Northern Access Road, Havant Thicket Reservoir, Havant

RSA Combined Stage 1 and 2

Portsmouth Water

November 2022

Figure 2-1 – User restriction signs

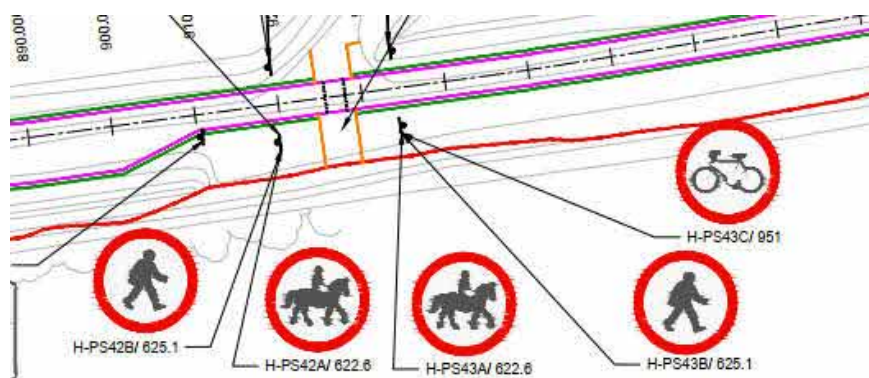
The proposals include the erection of 'no pedestrians/cyclists/horse rider' signs at either end of the track and where footpaths cross the track as shown in figure 2-1. The RSA team had concerns that these signs are not always understood by members of the public which could lead to prohibited users entering the track and being involved in a collision with a vehicle. This problem could become more pertinent during construction where pedestrians and cyclists may not be seen by drivers of large construction vehicles and may be less aware of vehicular traffic due to the irregularity of traffic using the route. Existing cycle route signs mounted on timber posts along the track indicate that it is currently used by cyclists.

Although supplementary plates are not prescribed by the TSRGD it is recommended that sub plates such as 'no pedestrians' etc are installed alongside the prescribed signs to inform the public of the prohibitions. It is also recommended that existing cycle route signs on timber posts are removed.

Figure 2-4 – Passing place spacing

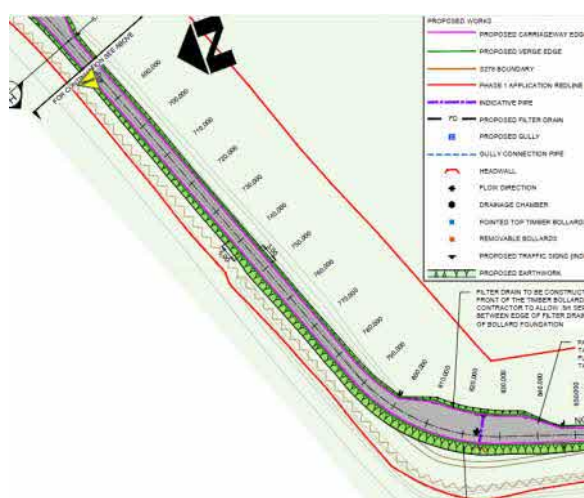
Passing bays are proposed at intervals along the access road to facilitate two-way traffic movements. A 150m stretch of single track has been identified with no passing places between Ch 660 and 810 as illustrated in Figure 2-4. TAL 02/04 recommends a distance of no more than 60m between passing places. This section also lies on a downhill gradient for southbound traffic.

The RSA team had concerns that southbound drivers may be reluctant to wait in the passing bay at Ch 660 to allow for a northbound vehicle to travel 150m, particularly as they will be gathering momentum on the downhill gradient. This could result in northbound vehicles being forced to reverse back along the track to allow a southbound vehicle to enter the passing place at Ch 810. Reversing manoeuvres along the track would increase the risk of collisions with following vehicles.

It is recommended that an additional passing place is provided between Ch 660 and Ch 810.

Figure 2-5 – Sign positioning at passing bay

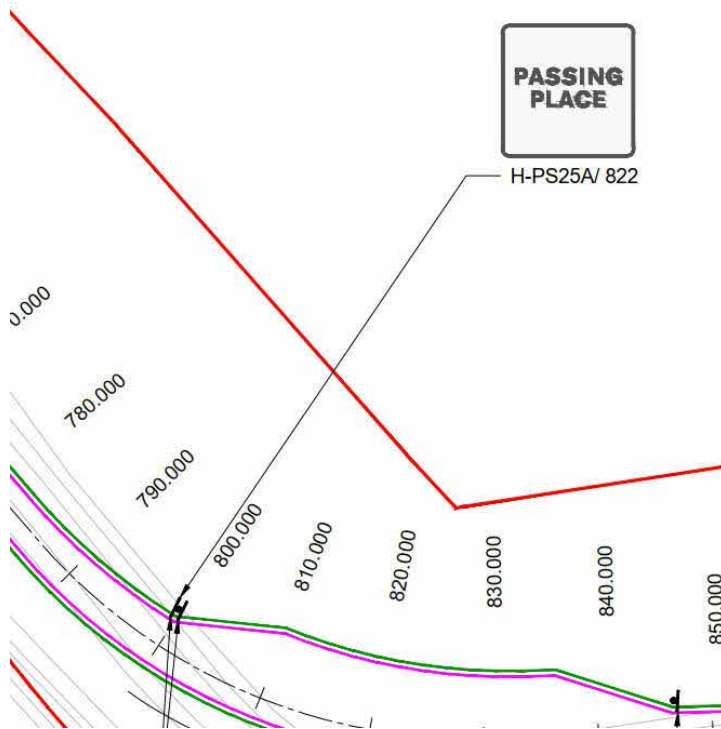
Passing bay signs are proposed at the change in kerb direction on the entry and exit tapers of the passing places. An example of this is provided in Figure 2-5. The swept path of an HGV is shown to pass very close to the signs at each passing place. Inadequate clearance between the signs and a large vehicle with lateral overhang could lead to sign strikes.

It is recommended that sufficient clearance is provided between the signs and the edge of carriageway.
